Re: Record of Decision for the Fire Training Areas at the Seneca Army Depot Activity Superfund Site, Romulus, New York

**FINAL
RECORD OF DECISION (ROD)
THE FIRE TRAINING AND DEMONSTRATION
PAD (SEAD 25) AND THE FIRE TRAINING PIT
AND AREA (SEAD 26)
SENECA ARMY DEPOT ACTIVITY**

RESPONSE TO COMMENTS

Response to Comments from the United States Environmental Protection Agency

**FIGURE 3-1
LAND REUSE MAP**

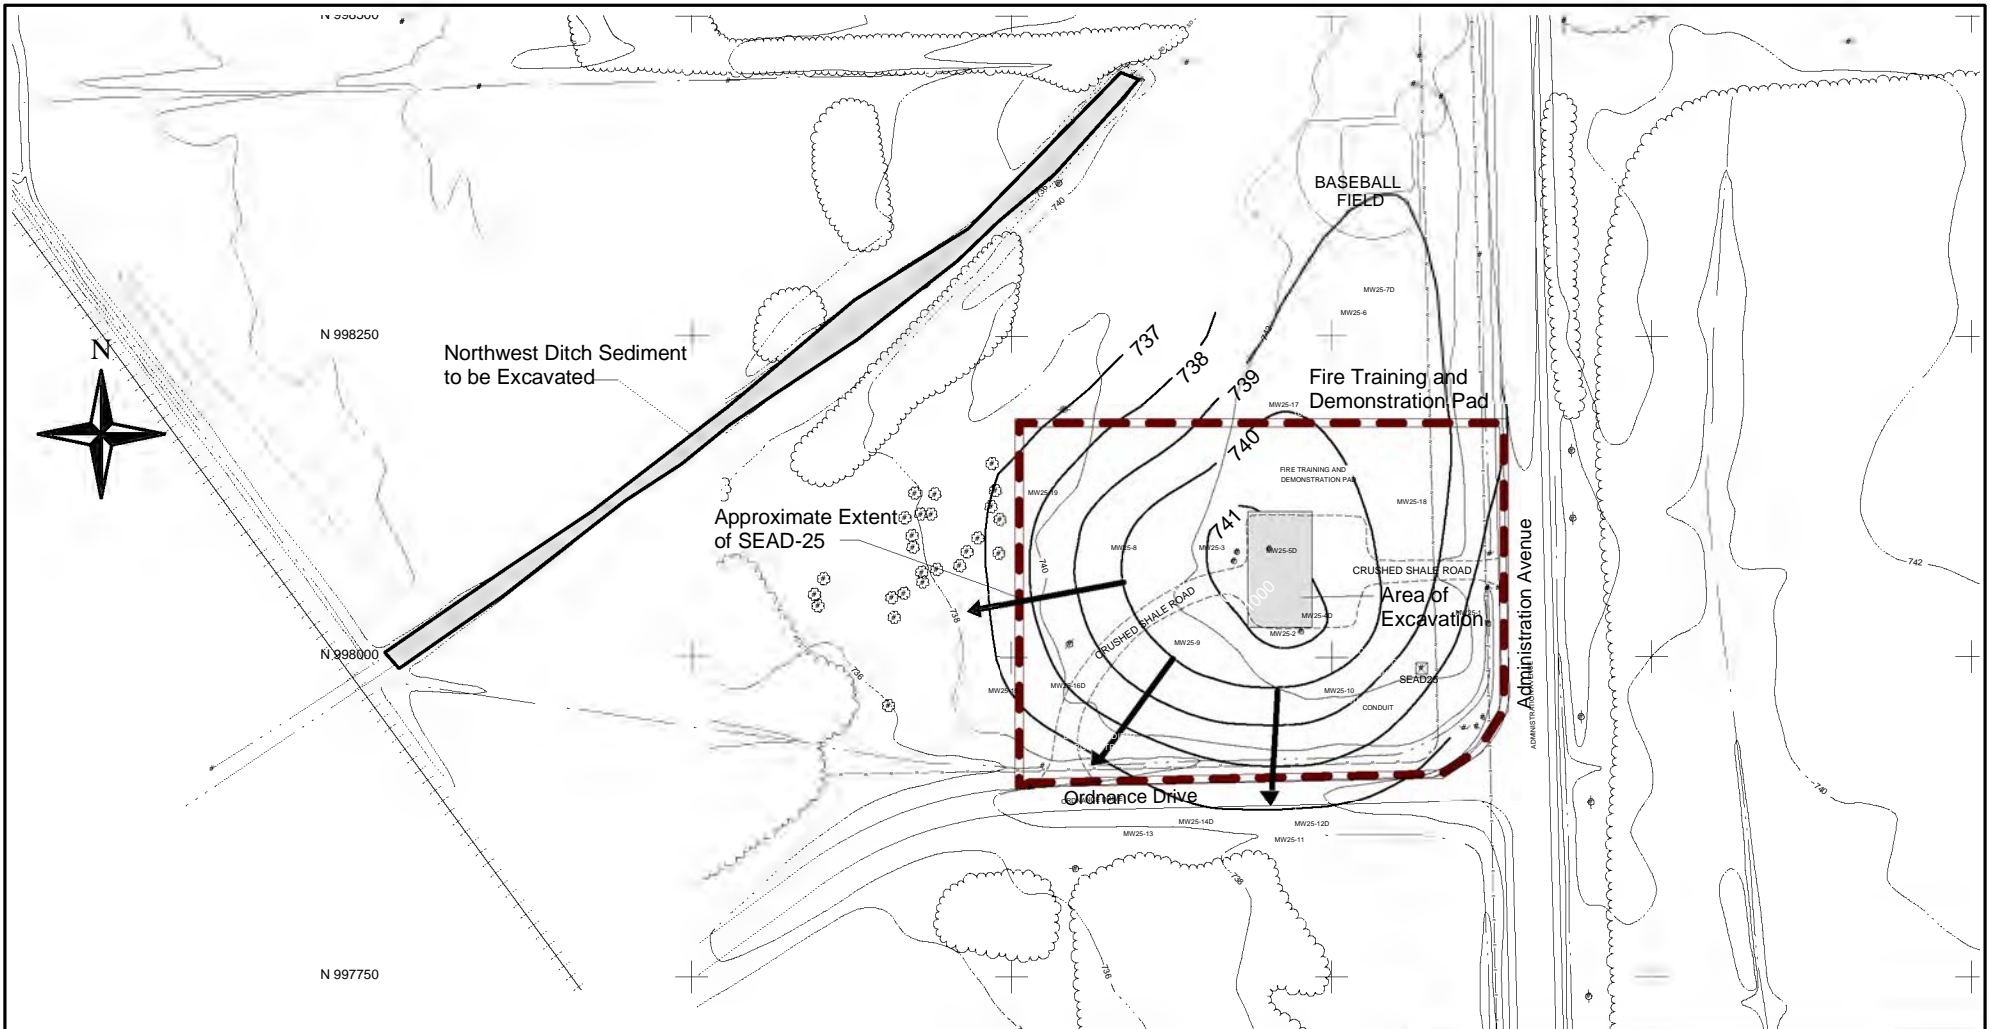
Comment 50: Figure 3-2: It would be helpful if this figure included the locations of SEADs 25 and 26.

Response 50: Assuming that the reference is to Figure 3-1, agreed. The location of SEAD-25/26 has been indicated on the map.

Figure 6-1
SEAD-25 Areas to be Remediated
Showing Groundwater Flow
Direction and Elevations

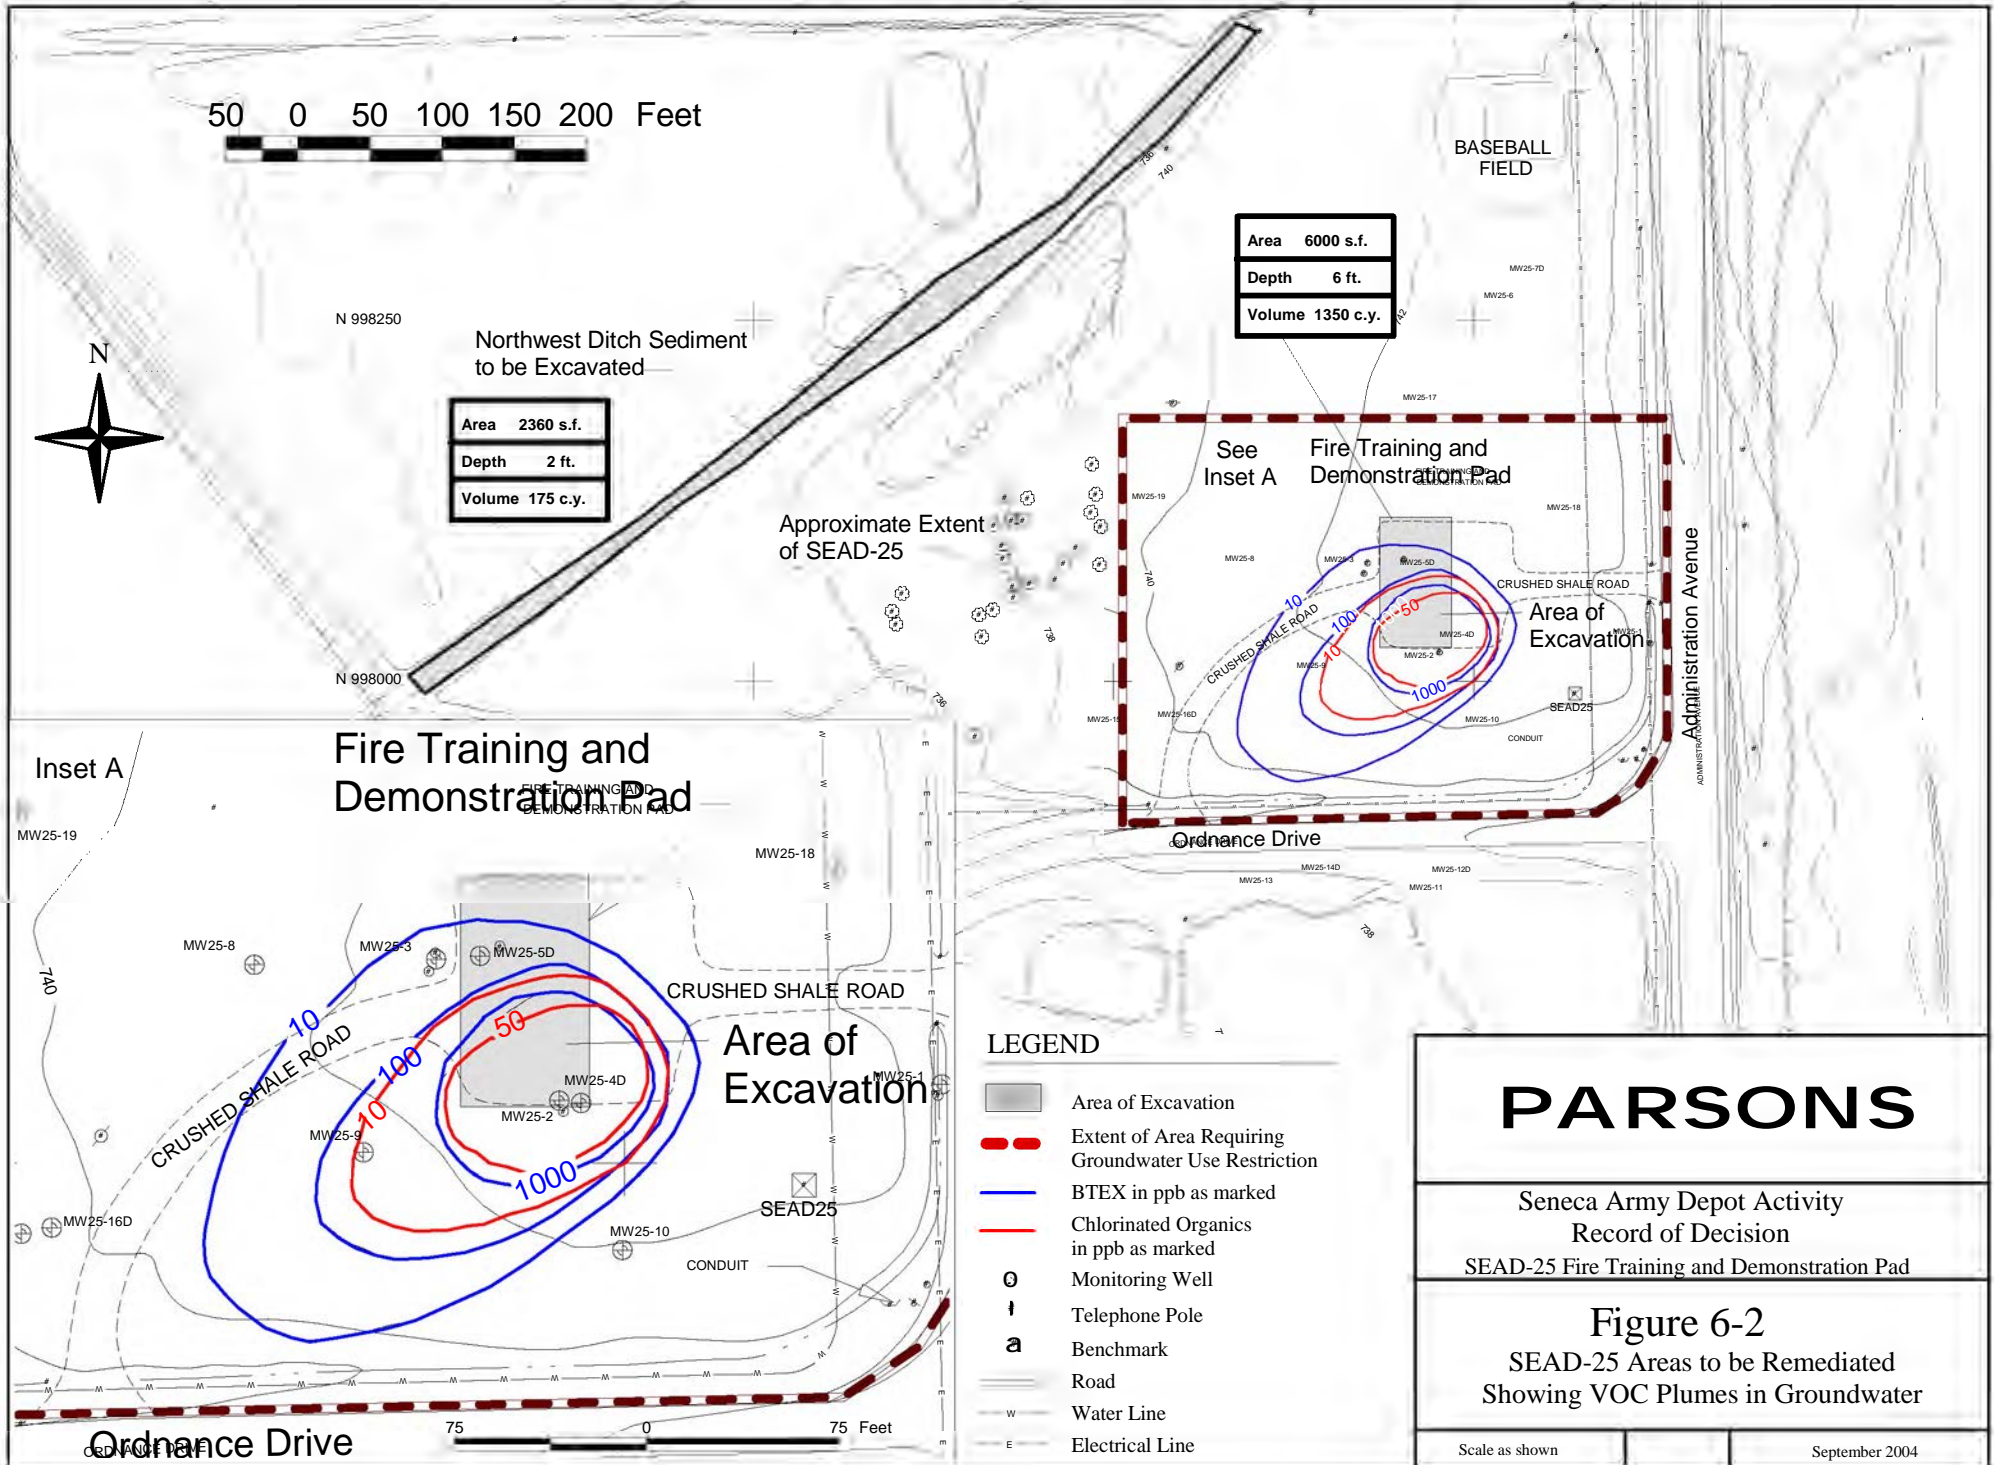
Comment 49: Figure 6-1: The groundwater flow direction in this figure does not correlate well with the plume sketches on Figure 6-2.

Response 49: Agreed. Figure 6-1 has been modified to more clearly illustrate the direction of groundwater flow. In addition, the following discussion on groundwater flow has been added to the text in Section 6.1.2, *Impacts to Groundwater*:

“The groundwater flow direction is shown in Figure 6-1. Results of groundwater contour mapping indicate that groundwater flow is radial below the pad, with a strong horizontal gradient to the south and west. The radial groundwater flow that has developed below the pad at SEAD-25 is believed to be a local phenomenon that is present because of the influence of the anthropomorphic bedrock topographic mound located below the pad. The mapping also indicated that the groundwater flow in the deeper portion of the aquifer located in the competent shale zone is to the west and southwest.”
